# UNITED STATES PATENT AND TRADEMARK OFFICE

APPLICATION NO.	FILING DATE	FIRST NAMED INVENTOR	ATTORNEY DOCKET NO.	CONFIRMATION NO.
10/760,129	01/16/2004	Peter S. Brown	ENDOV-63893	7202
24201	7590	06/12/2006	EXAMINER	
FULWIDER PATTON 6060 CENTER DRIVE 10TH FLOOR LOS ANGELES, CA 90045			MILLER, CHERYL L	
			ART UNIT	PAPER NUMBER
			3738

### DETAILED ACTION

**FIG. 4**

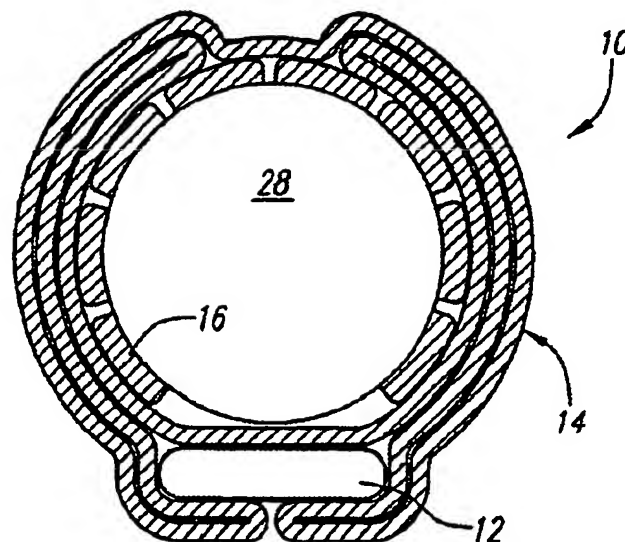
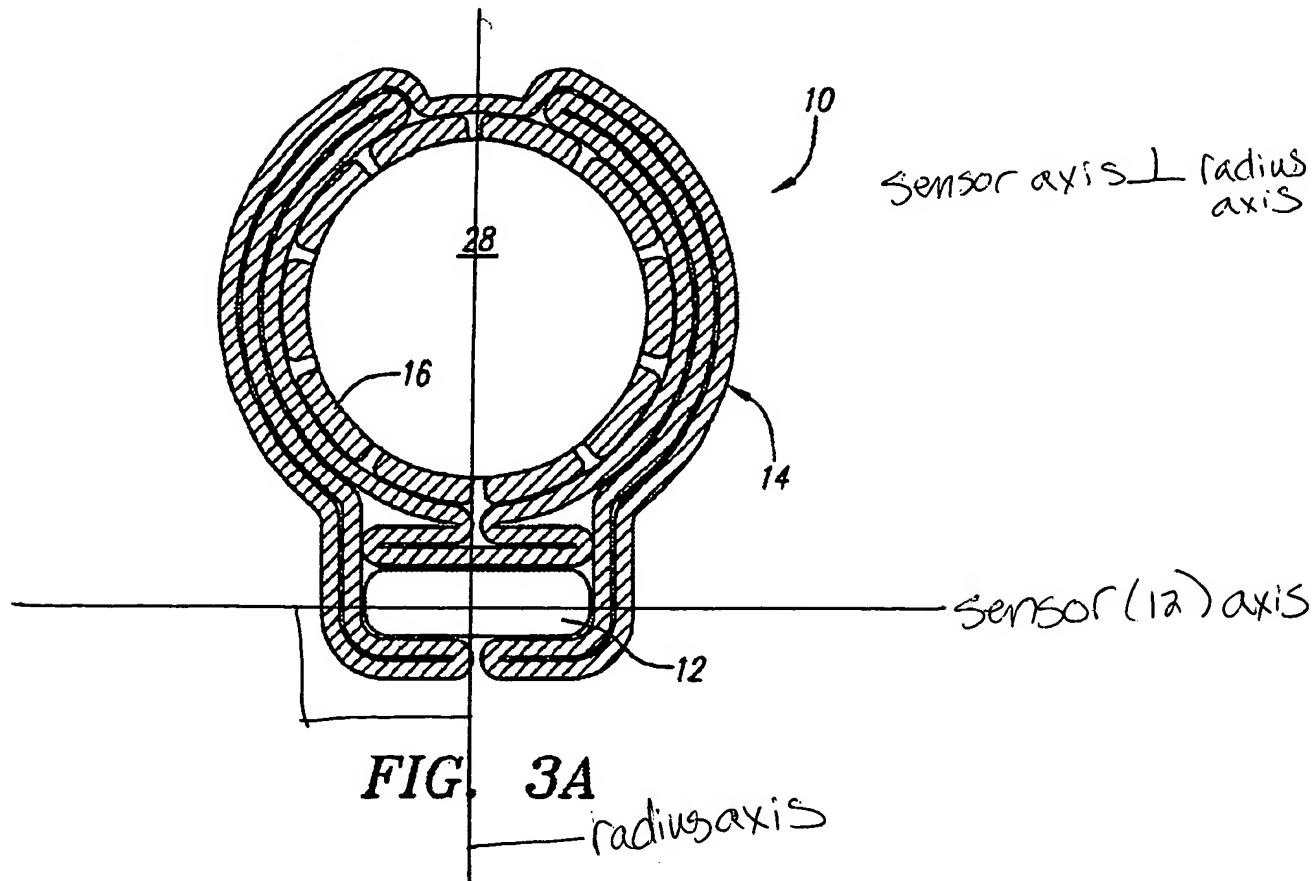
Claims 1 and 8 are rejected under 35 U.S.C. 102(b) as being anticipated by Reich et al. (US 2002/0183628 A1). Reich discloses a method of protecting a sensor attached to a graft comprising configuring a membrane of a sensor (s1, s2, s3) so that the membrane is substantially perpendicular to a radius of an unfolded graft (seen clearly in fig.3, 4; attachment 1), attaching a sensor (s1, s2, s3) to the unfolded graft (inner layer 20), folding a graft material (patch) to cover the sensor (placing a patch over the first unfolded graft may be considered to be “folding graft material over the sensor”; since the “graft material” is not required by the claim to be part of the unfolded graft, it may be considered a separate piece, such as a patch, which may be folded down onto the over the unfolded graft; see P0029) and placing the graft within a catheter (40).

Reich discloses a single folded section (patch) of graft material covering the sensor (s1, s2, s3).

Sensor axis  $\perp$  radius axis

FIG. 3A

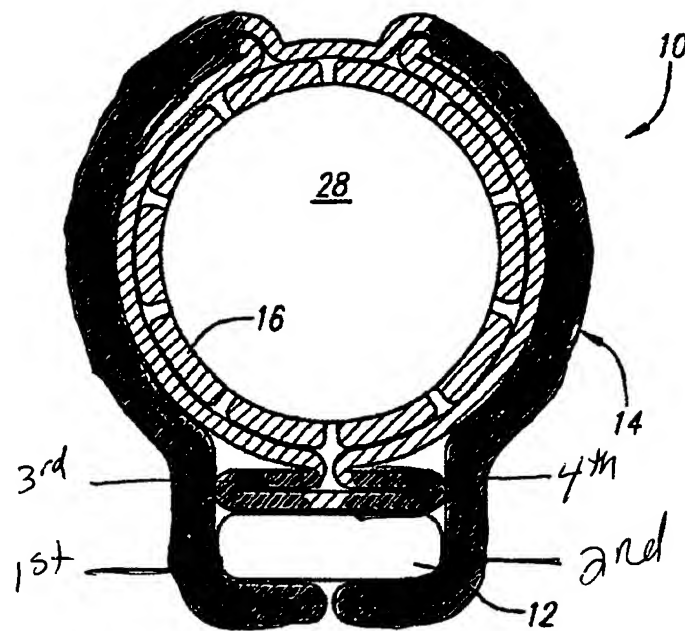
Wolinsky discloses a single or multi folded section of graft material covering the sensor (figs.3A, 3B). Wolinsky discloses configuring the graft to an H-shape (fig.3A may be considered an H-shape as it is similar to the configuration shown by applicant's own figures; see attachment 3).

★ 4 legs of  
"H" seen  
shaded in red  
separately

FIG. 3B

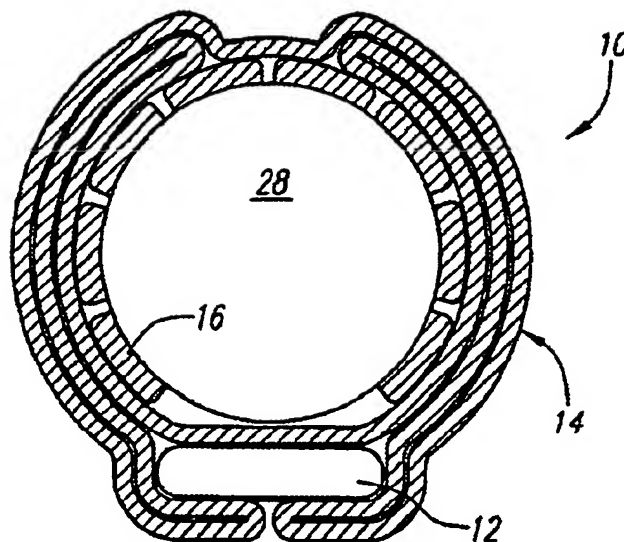
Claims 1, 2, 4, 7, 8 rejected under 35 U.S.C. 102(e) as being anticipated by Wolinsky et al. (US 6,840,956 B1, cited previously. Wolinsky discloses a method of protecting a sensor attached to a graft (col.5, lines 38-45) comprising; configuring a membrane of a sensor (12) so that the membrane is substantially perpendicular to a radius of an unfolded graft (see attachment 2), attaching a sensor (12) to the unfolded graft (14), folding a graft material to cover the sensor (see either fig.3A or 3B) and placing the graft (14) within a catheter (32).
